#### **NEYVELI UTTAR PRADESH POWER LIMITED**

# OFFICE OF THE CHIEF GENERAL MANAGER/PROJECT HEAD PACHWARA SOUTH COAL MINE PROJECT,

Sub:	Compliance to the EDS raised by MoEF & CC, Communicated through Letter No. 8-37/2022-FC; dt. 08.03.2024 in respect of the FC proposal Pachwara South Coal Block.		
Ref:	Proposal No. FP/JH/MIN/59823/2020 Dated 20/11/2020 for seeking prior approval of Central Government under Section 2 of the Forest (Conservation) Act,1980 for diversion of forest area.

Figure No 1.2: Plan showing various options of Transportation with respect to Pachwara South Coal Block.

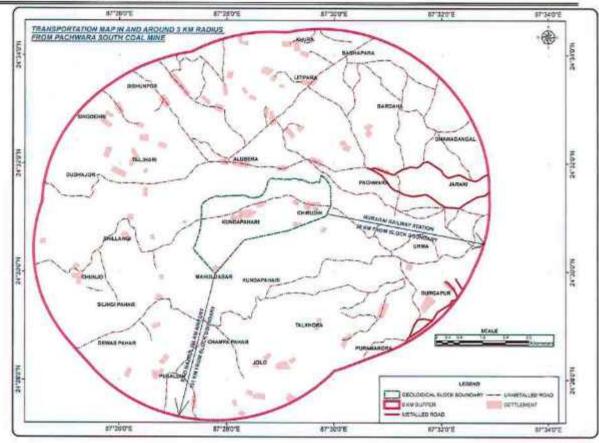
3.	The State Government has not furnished KML file showing the proposed route for transportation of the coal. The same need to be furnished.	Coal Transportation from Pachwara South Coal Mine involves road transportation through existing road along the northern bank of Bansloi river upto Amrapara and thereafter upto Kurwa Siding (Dumka) where dedicated siding for Pachwara South coal Mine is being constructed. The route of coal transportation is shown in Annexure-III and the KML file has been attached in CD format.
